**AGENDA**  
**TULSA METROPOLITAN AREA PLANNING COMMISSION**  
**Meeting No. 2751**

August 2, 2017, 1:30 PM  
175 East 2nd Street, 2nd Level, One Technology Center  
Tulsa City Council Chamber

### **Magnolia Ridge** - (County)

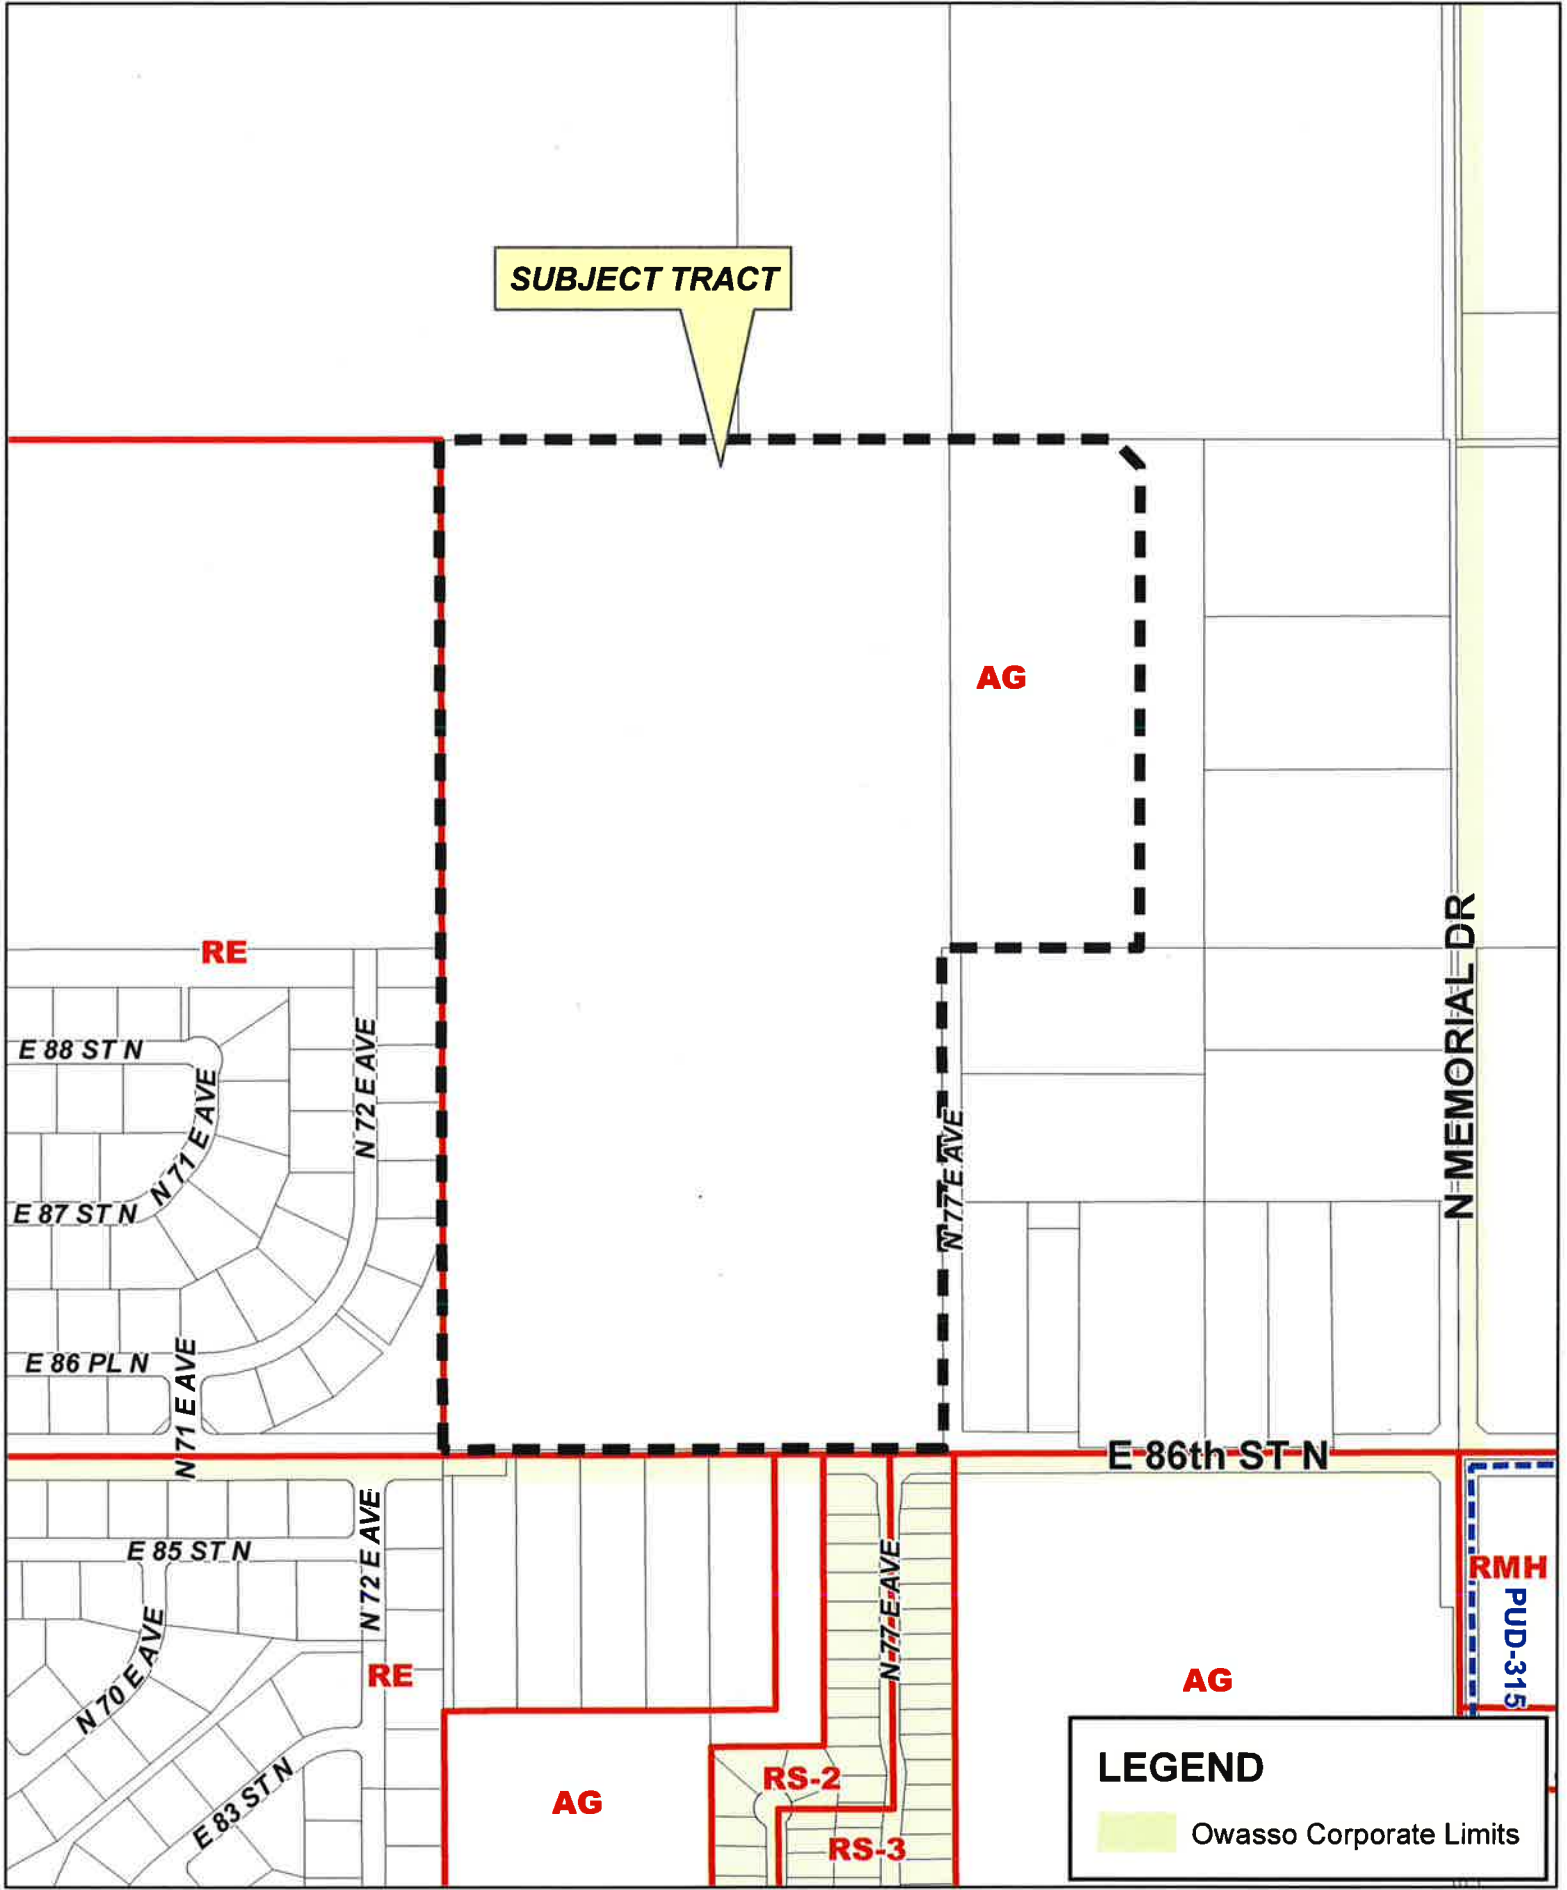
1. **Zoning:** All property within the subdivision has been rezoned to RS (Residential – Single Family). All proposed lots conform to the requirements of the Tulsa County Zoning Code.

2. **Addressing:** Addresses will be assigned by INCOG.
3. **Transportation & Traffic:** Sidewalks shall be provided on both sides of residential streets and shall be observed in the covenants.

4. **Water:** Water line plans must be submitted to Rural Water District No. 3, Washington County. All requirements of the district must be met for final plat approval.

5. **Sewer:** Sanitary sewer service to be provided by City of Owasso. Release will be required from City of Owasso for final plat.
5. **Engineering Graphics:** Submit a subdivision control data sheet with final plat. Provide addresses for individual lots on final plat. Provide street names on face of plat. Show only platted subdivision boundaries in the location map and label all other property as “unplatted”. Add street labels to location map. Ensure accuracy and consistency between written legal description and bearing angles shown graphically on the face of the plat.

6. **Stormwater, Drainage, & Floodplain:** Drainage plans must comply with Tulsa County standards. Any required easements must be properly located and dimensioned on final plat.

7. **Utilities: Telephone, Electric, Gas, Cable, Pipeline, Others:** All utilities indicated to serve the site must provide a release prior to final plat approval. Cox Communications has requested additional easements attached as “Exhibit A”. Provide a Certificate of Records Search from the Oklahoma Corporation Commission to verify oil & gas activity on the site. Provide plugging records for any plugged wells on site. 125’ building setback is required from any active well or known well bore.

Staff recommends **APPROVAL** of the preliminary subdivision plat subject to the conditions provided by TAC and the requirements of the Subdivisions Regulations.
